**LEGAL ADVERTISEMENT
PORTLAND PLANNING BOARD MEETING
REVISED AGENDA**

The Portland Planning Board will hold a meeting on Tuesday, August 8, 2017, Council Chambers, 2nd Floor, City Hall, 389 Congress Street.

Re: August 8, 2017 Planning Board Workshop
MMC's Institutional Development Plan Update

SHEET 2 OF 7

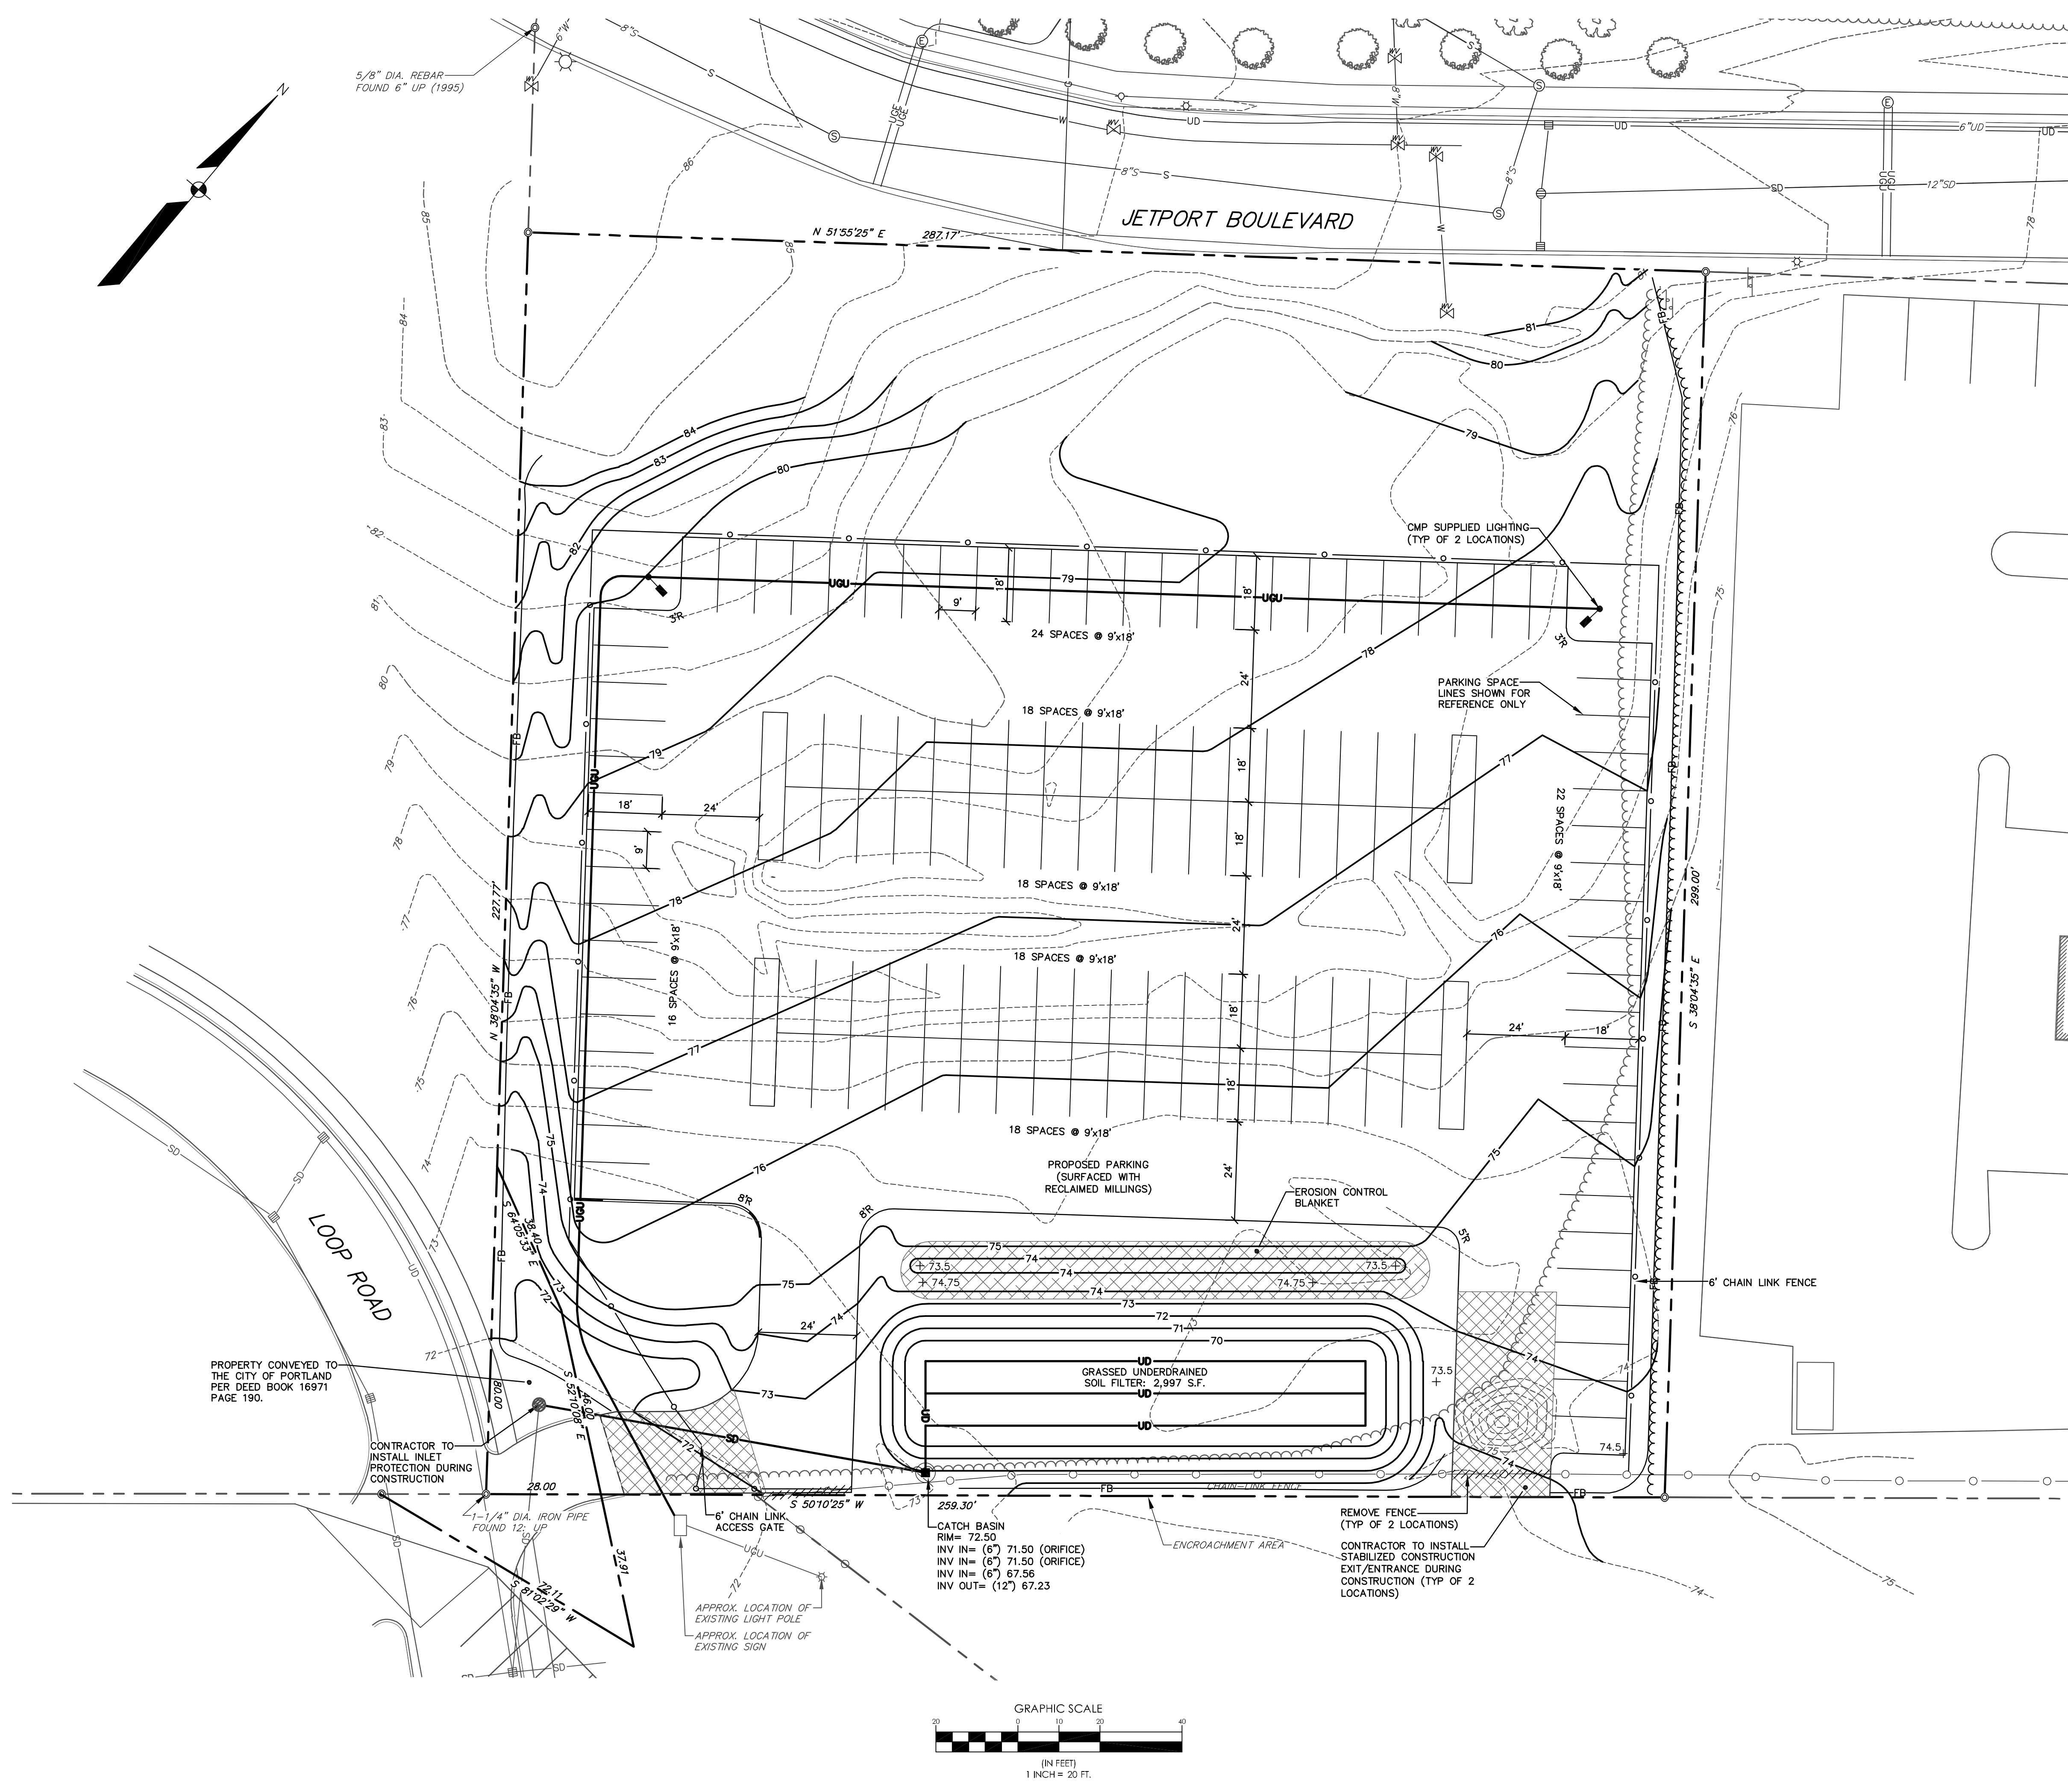
Sheet 2 of 7 notes that the southern corner of the property was conveyed to the City of Portland; the City-owned property contains a catch basin that the applicant is proposing to connect to via the storm drain outlet from the underdrained soil filter. Stormdrain pipes are not permitted to be connected into City of Portland catch basins per the City of Portland Technical Manual, Section 2.7.8. The applicant should propose an alternate means of connection or work with the Department of Public Works to determine if the proposed approach is acceptable.

2. Sheet 2 of 7 indicates an "Encroachment Area" south of the underdrained soil filter; the Applicant should clarify what this area is.
3. Sheet 2 of 7 notes that the southern corner of the property was conveyed to the City of Portland; this City-owned property contains a catch basin that the Applicant is proposing to connect to via the storm drain outlet from the underdrained soil filter. Stormdrain pipes are not permitted to be connected into City of Portland catch basins per the City of Portland Technical Manual, Section 2.7.8. The Applicant should propose an alternate means of connection or work with the Department of Public Works to determine if the proposed approach is acceptable.
